Preliminary report on the proposed Little Sandstone Reservoir Site

James C. Case and Alan J. VerPloeg

GEOLOGIC HAZARDS IN THE VICINITY OF THE PROPOSED LITTLE SANDSTONE RESERVOIR
BY JAMES C CASE AND ALAN J VerPLOEG

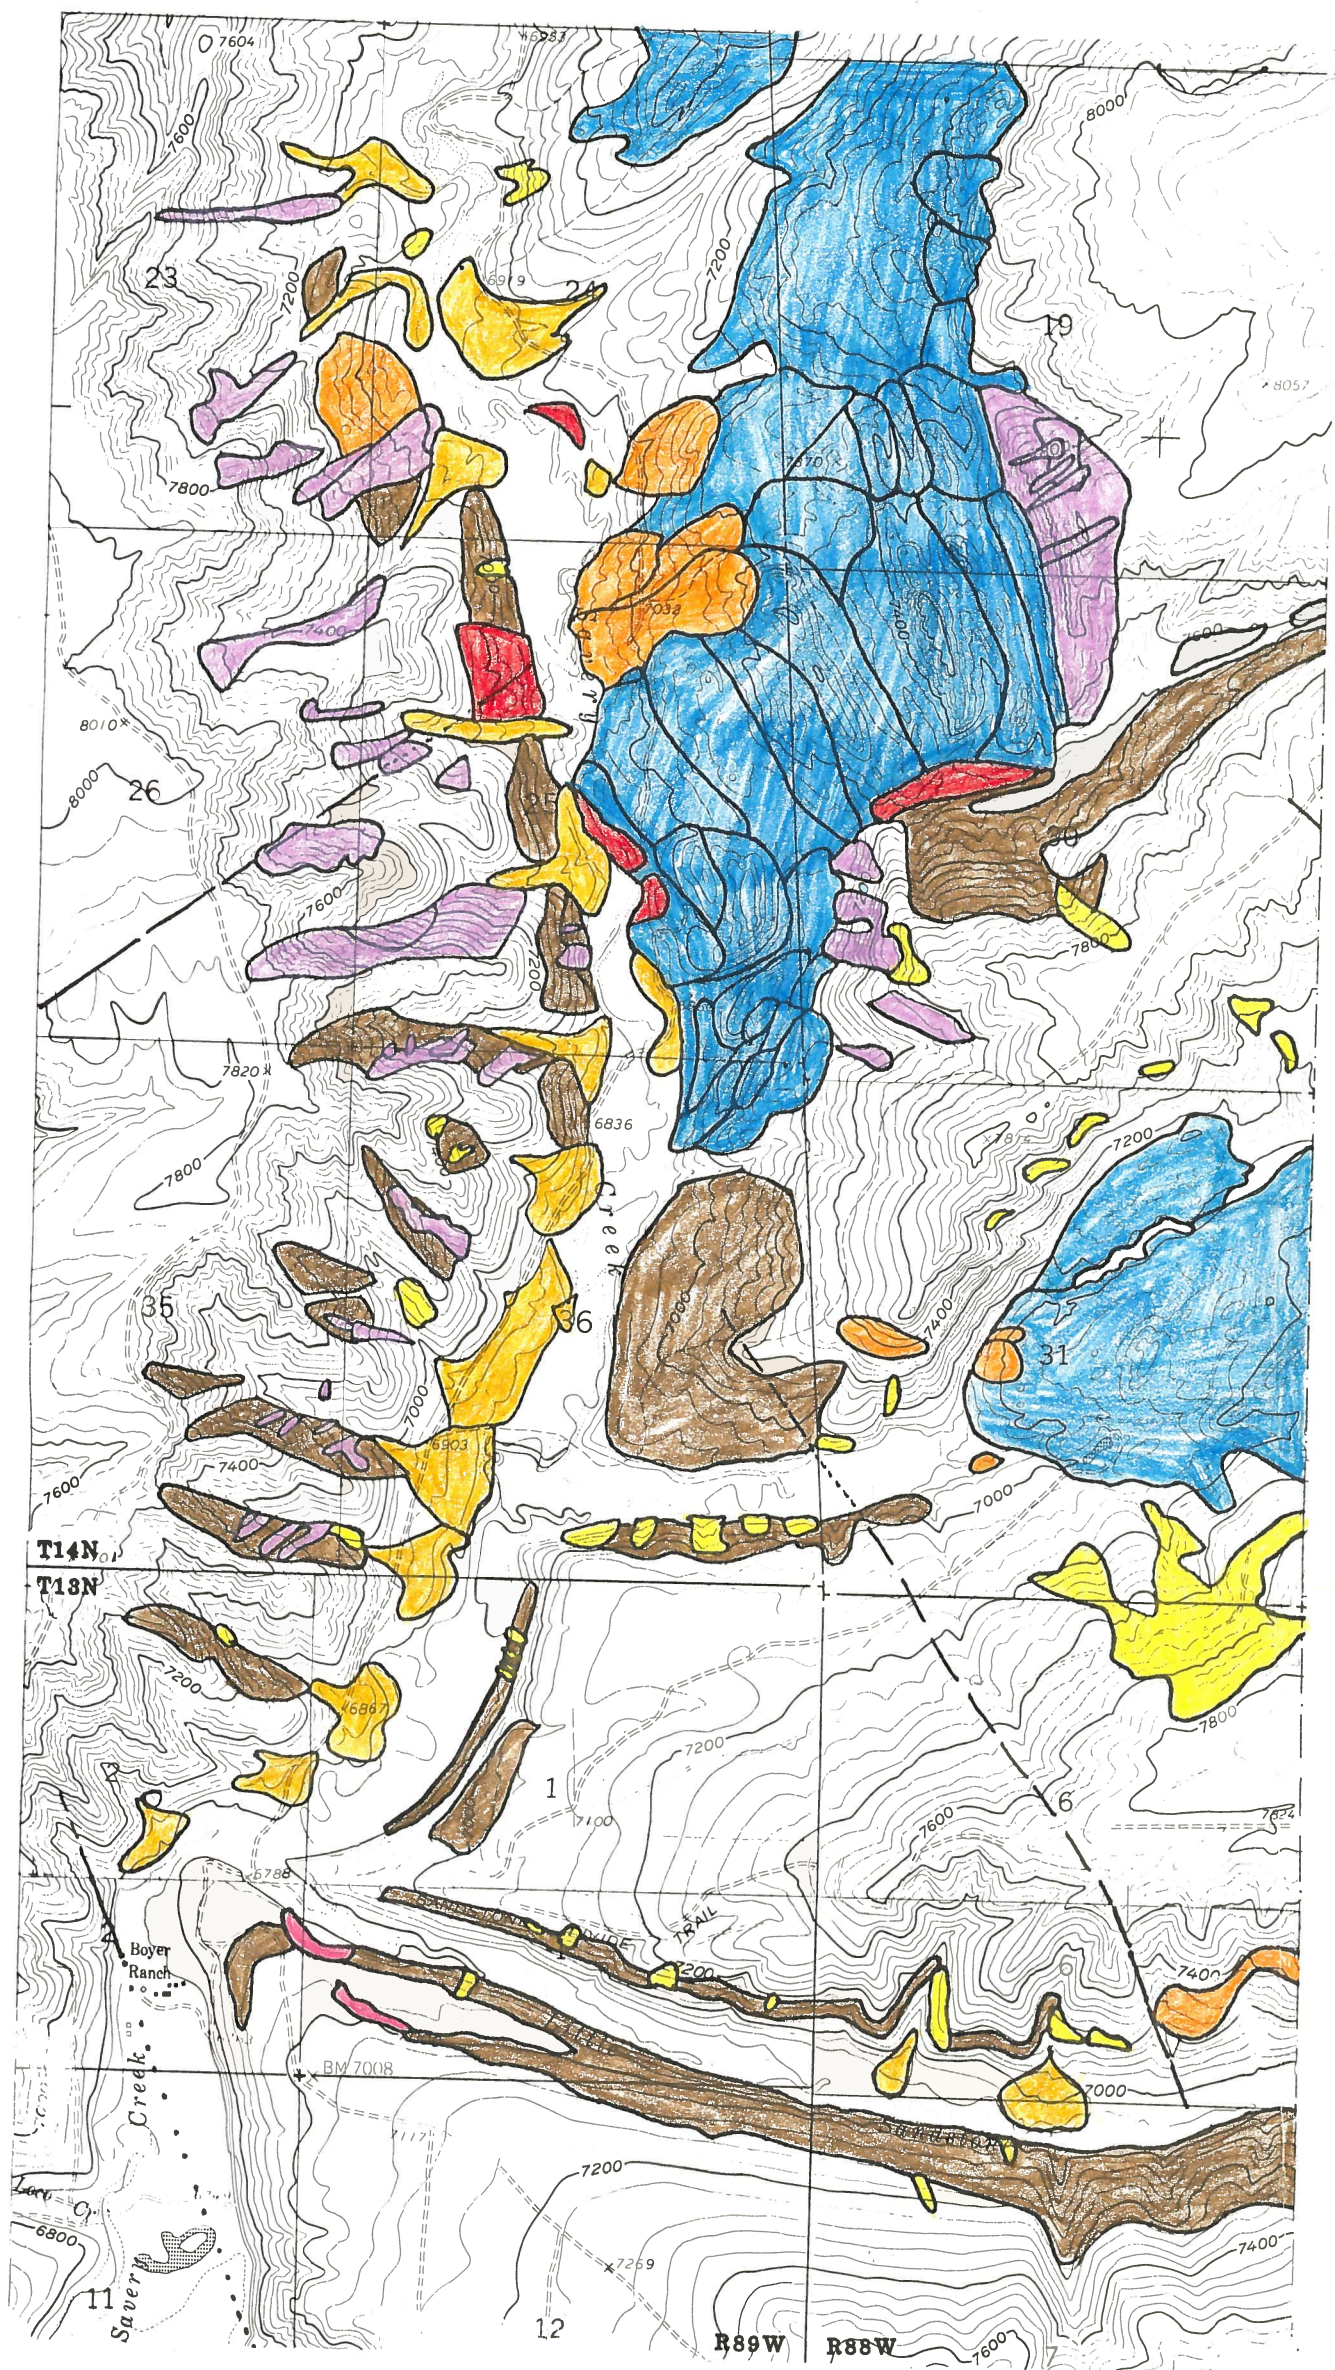
There are two major rock block slide-block glide complexes in the study area. They are relatively deep seated, composed of bedrock and cover large areas (see enclosed map). These large block slides and glides found in the area are of the type that are generally slow moving. A rapid catastrophic movement would be very unusual as both complexes are already encroaching on the opposite valley walls. If they destabilized suddenly, they could not move any appreciable distance.

The large block slide complex along Savery Creek does have other slope movements associated with it that may react more quickly to increased saturation. As can be seen on the enclosed map, there are a few sizable slump-flows (probably debris laden earthflows) that have formed from both the rubble derived from the block slides and from the block slides themselves. If those flows were

There are numerous zones of talus or weathered bedrock that have destabilized in the form of flows, slumps or slump-flows. Most of the movements are shallow and should not be directly affected by the reservoir. However, they will be a continuing source of sediment. As can be seen on the enclosed map, many of the talus and weathered bedrock movements are on north-facing slopes.

In summary, there are many slope movements and slope movement types in the study area. Existing movements as well as areas that may be prone to certain types of movement have been delineated on the enclosed map. Much of the interpretation has come from analysis of aerial photography. Classifications and locations may change when the whole area is examined on the ground.

As a suggestion, if the proposed high water line is plotted on the enclosed map of geologic hazards, areas that will be saturated or subjected to fluctuating water levels can be delineated. Various types of worse case scenarios can then be generated. The scenarios can be created for various depths of material that will move into the reservoir and various periods of time over

Close examination of the east abutment revealed no obvious slump scarps although one area was flagged as having a potential for small scale shallow slumps. That area is delineated on the enclosed map. There was only marginal evidence for what could be construed as a highly weathered small scale slump in that area.
